HUALAPAI INDIAN NATION PEACH SPRINGS, ARIZONA IFB NO. 03-2023

Pre-Bid Questions and Answers on Invitation for Bids from Residential Building Contractors for Renovation of Single-Family Home in Peach Springs, AZ

ADDENDUM NO. 2

Response to Questions

New Construction Floor Plan

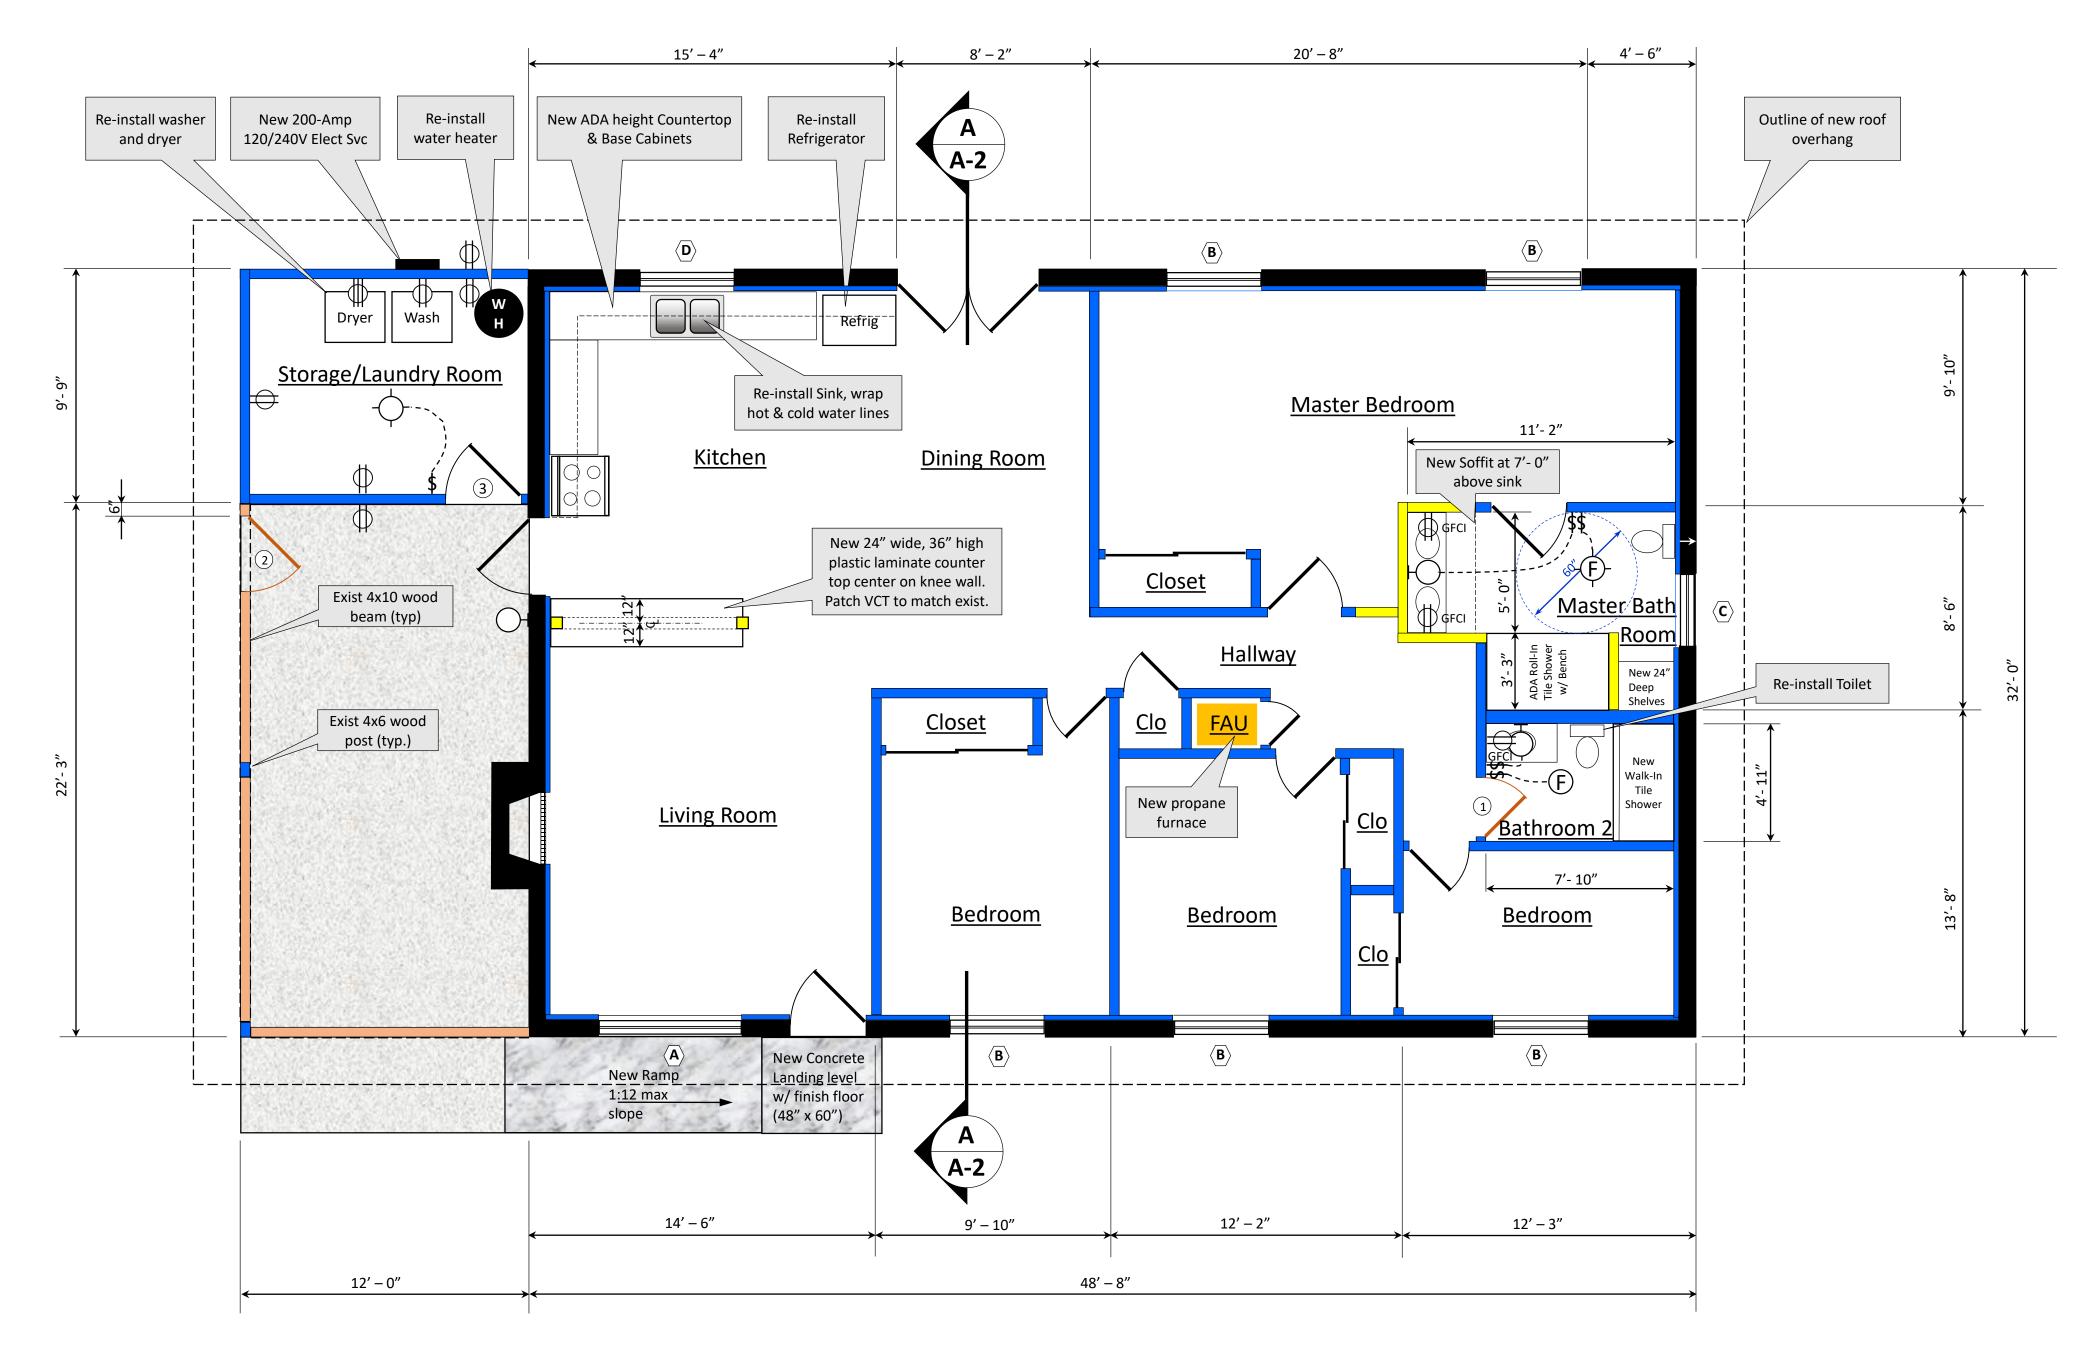
- 4. Will the wall dividing the Living Room and Kitchen be removed or cut down to a knee wall with a bar top? Yes (see attached plans). The design also includes installing a new 4x10 header support by 4x4 end posts to support roof trusses.

- 7. Will the owner be able to move furniture to repaint the interior walls and ceiling that must be repainted where drywall is being repaired? Yes.
- 8. Where will the new exterior door be located for Bid Additive No. 5? See attached plans.
